CONSTRUCTION PHOTOS OF EUT

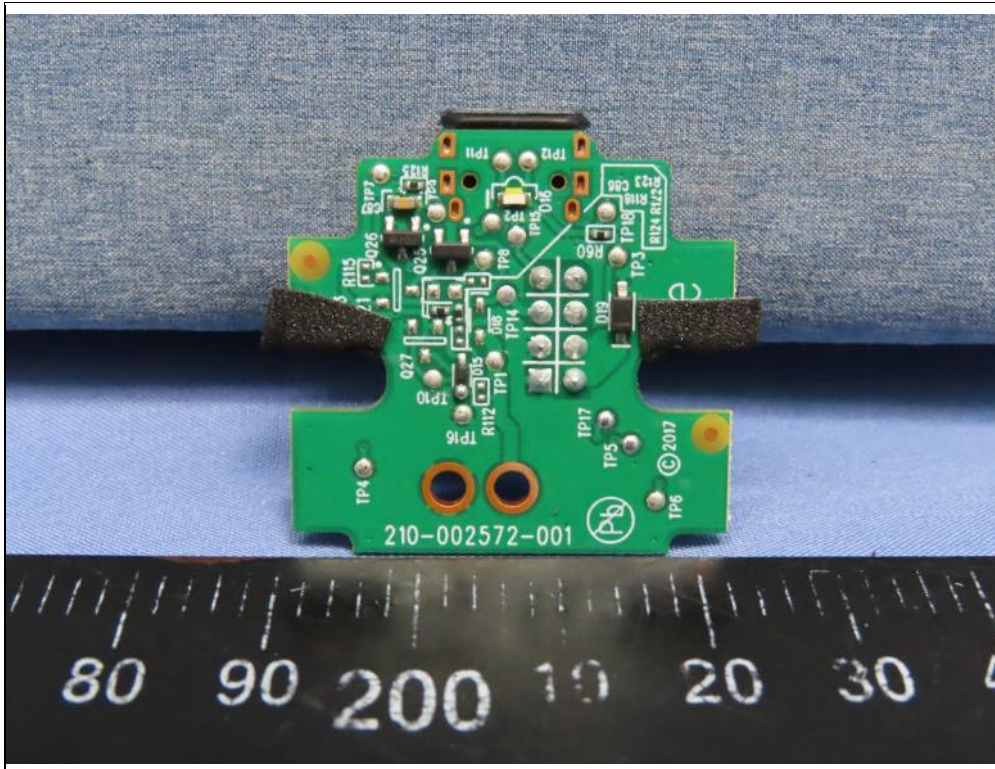
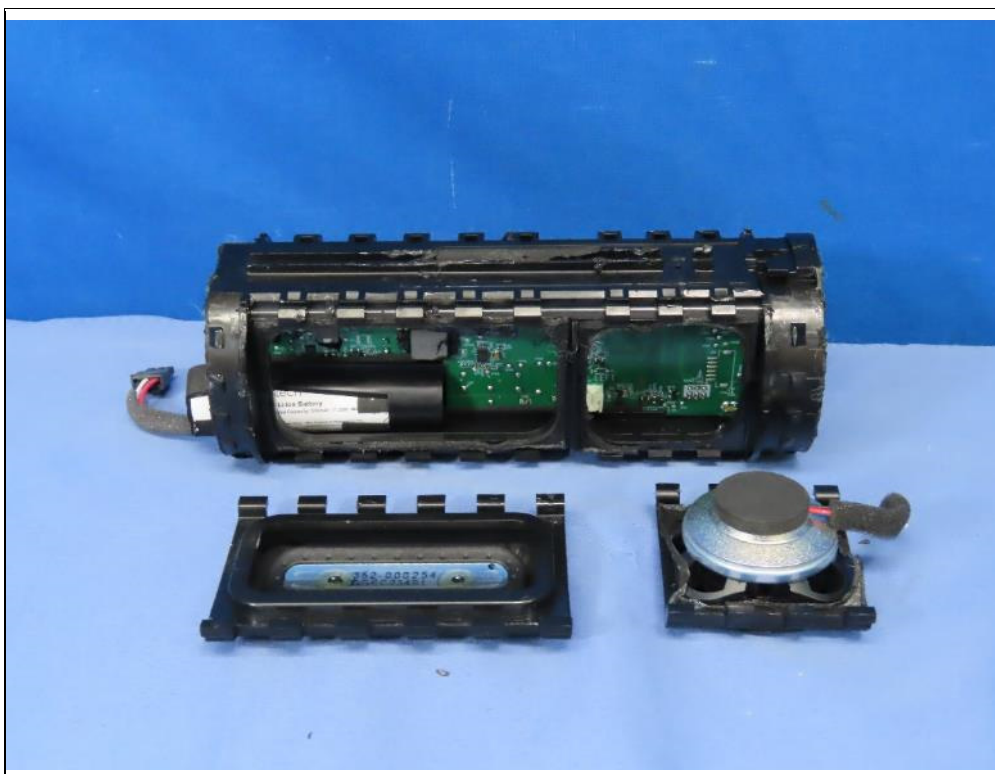
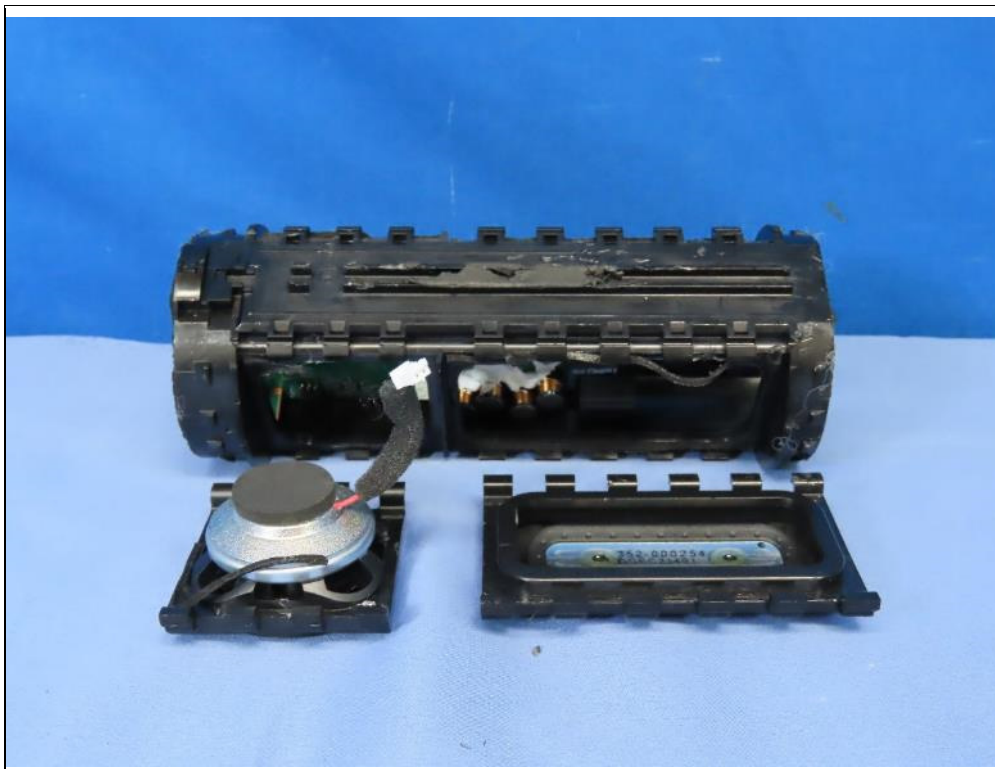
Change Top/Vol board from 2Layers to 1Layer

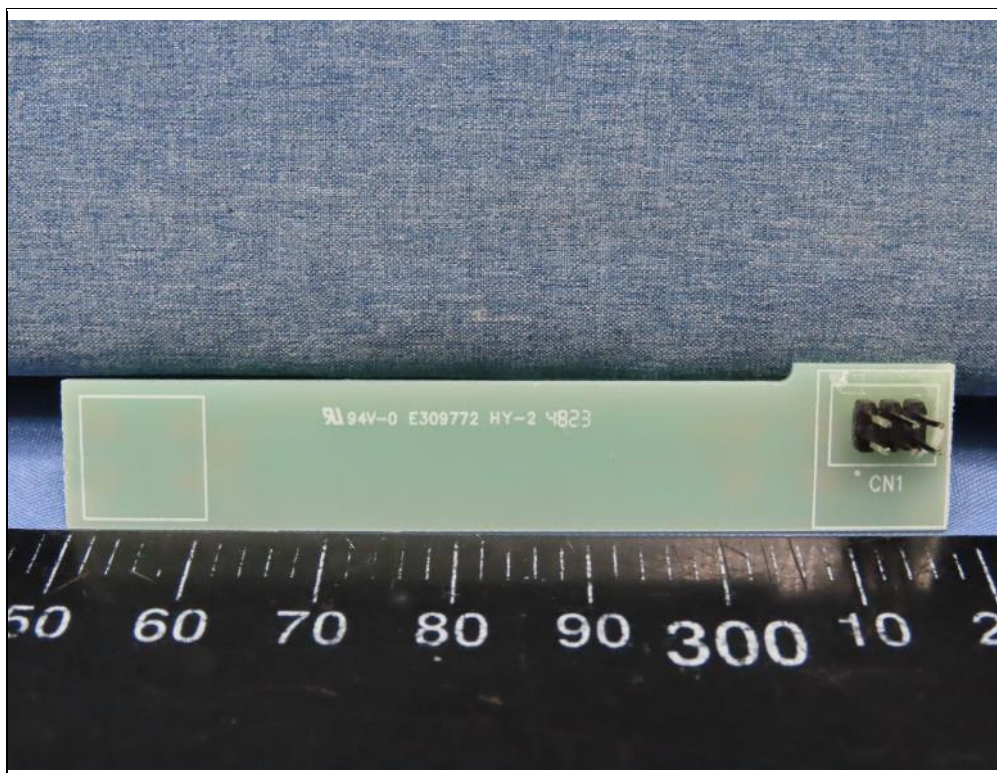
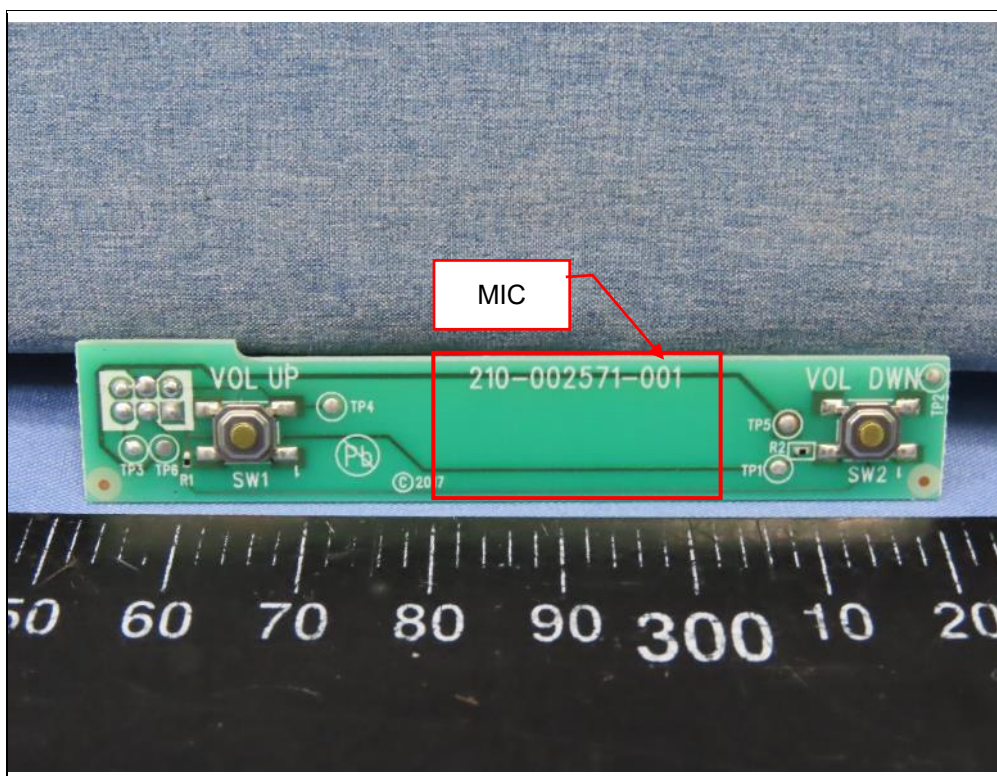
Change Top/Vol board from 2Layers to 1Layer, and remove the layout of MIC from Vol board

Change Inductor of AMP (L5-L8) from 302-000435 to 302-000413 / Remove C127 capacitor
